Form 3160- 5 (April 2004)

SUNDRY NOTICES AND REPORTS ON WELL	SUNDRY	NOTICES	AND	REPORTS	ON	WELLS
------------------------------------	--------	---------	-----	---------	----	-------

2. Name of Operator				Rincon Unit	#503
Chevron MidContinent, L.P.		Total Phase No. 6. 1		9. API Well No	
3a Address P.O. Box 36366, Houston, TX	77236	3b. Phone No. (mch	ŕ	30-03	9-29691

EIGHT POINT DRILLING PLAN

CLASS III BOP SCHEMATIC

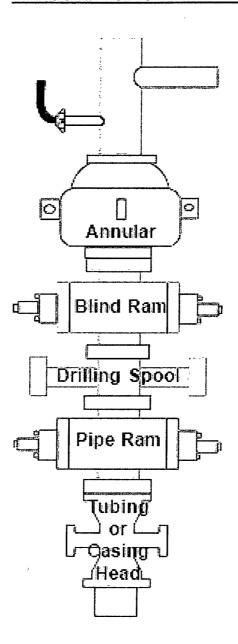
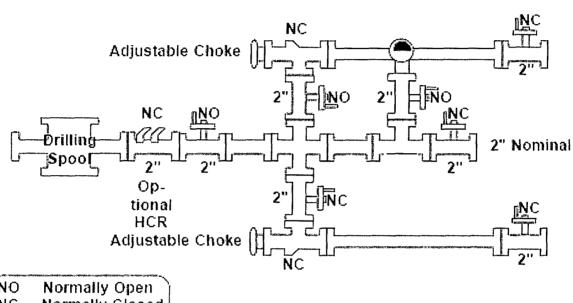
II. Since no BOPE test pressures were proposed, it is recommended that Chevron MidContinent L.P. test the BOP and related equipment according to Onshore Order No. 2 Minimum Standards and Enforcement Provisions For Well Control Equipment Testing.

*Test BOPE to a minimum of 1200 psi based on an anticipated surface pressure of 1028 psi. Report all BOPE and casing pressure test results on sundry form 3160-5.
